SITE PLAN REVIEW AND APPEARANCE BOARD STAFF REPORT

382 SE 2nd Avenue

Meeting	File No.	Application Type
September 28, 2022	2022-206-SPF-SPR-CL1	Class I Site Plan Modification
Property Owner	Agent	
Corey Sardoss	Mark Borg

Consideration of a Class I Site Plan Modification associated with the installation of new impact storefront windows and doors to replace existing swing doors and overhead garage doors.

Description of Proposal

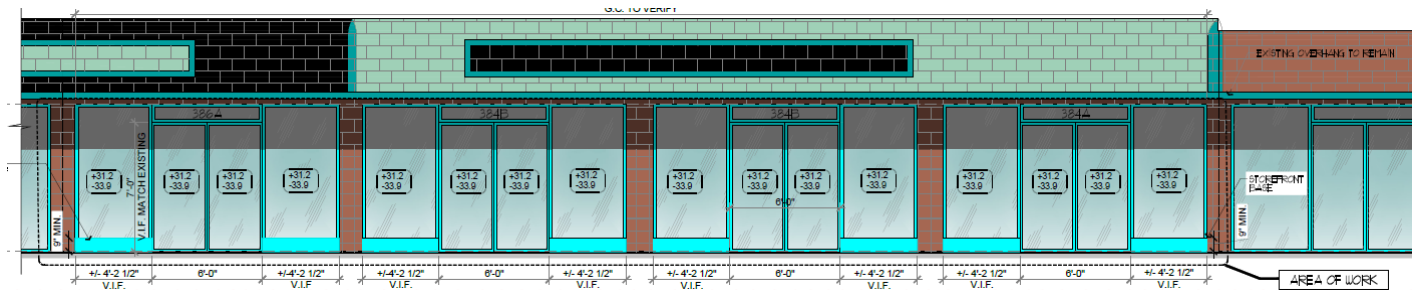
The request includes the removal of the existing swing doors, overhead garage doors and exterior concrete walls located in units 384A/B and 386A, and installation of aluminum framed storefront systems with impact glass and double door entrances. A nine-inch base is provided along the storefront windows flanking the entrances. It is important to note that there are no color changes associated with the request.

Standard/Regulation	Review
Building Setback	<p>Required: Storefronts shall be directly accessible from sidewalks; storefront doors may be recessed up to ten feet.</p> <p>Proposed: Storefronts are directly accessible from sidewalk. Setbacks are non-applicable for this proposal, due to the existing non-conforming building's setback and the proposal not altering existing setback.</p>
Storefront Base	<p>Required: Storefront windows shall have a base nine inches to three feet high.</p> <p>Proposed: The modifications include a storefront base of nine inches for Units 384A/B and 386A, which will establish consistency with the other units and reduce the existing nonconformity of the frontage type along the east elevation.</p>
Glazing Height plus Storefront Base	<p>Required: Transparent glazed windows shall extend from the base to at least eight feet in height as measured from sidewalk grade adjacent to the building. Transparent means non-solar, non-mirrored, glass with a light transmission reduction of no more than 20 percent.</p> <p>Proposed: The new storefront impact windows are eight feet in height including the nine inches from the storefront base.</p>

Required Openings	<p>Required: Storefront (window and door) openings shall extend along at least 80 percent of the width of the facade of the commercial space, measured by the sum of the widths of the rough openings.</p> <p>Proposed: The project is reducing the existing non-conformity, whereas 80 percent is not currently provided.</p>
Awning Projection	<p>Required: Storefronts shall have either awnings or an arcade. Awnings shall project a minimum of five feet from the building facade.</p> <p>Proposed: The existing building overhang, which measures approximately 24 inches to 30 inches (based on a Staff estimation), is not included in the proposed modifications and therefore, not required to meet the minimum dimension.</p>
Projecting Sign	<p>Required: Projecting sign shall encroach a maximum of three feet from the building facade.</p> <p>Proposed: Project does not propose any projecting signs. A separate request is required for any signage.</p>

Standard/Regulation	Review
Appropriate Architectural Styles 4.4.13(F)(3)	<p>Style: Main Street Vernacular with Storefront Frontage Type</p> <p>Style Details Utilized: Storefronts are generally composed of a base, one to three feet tall, with clear glazing that extends from the base to at least eight feet above the sidewalk level. Commercial windows and doors extend along at least 80% of the length of the facade of the space. The proper position of glazing on the facade ensures pedestrians are afforded a view of the merchandise and an interesting urban environment. Storefronts may incorporate arcades or awnings to provide shade and shelter.</p> <p>Proposed: The proposed glazing height of eight feet allows potential customers to view inside the retail stores and offers an opportunity for pedestrian-retail interaction. Although, the existing facade has an opening less than 80%, the proposal reduces the non-conformity and provides shade for pedestrians with the existing overhang.</p>

1. A note on the plan to specify and confirm compliance with the storefront requirement that the windows will be transparent, non-solar, non-mirrored, glass with a light transmission reduction of no more than 20 percent.
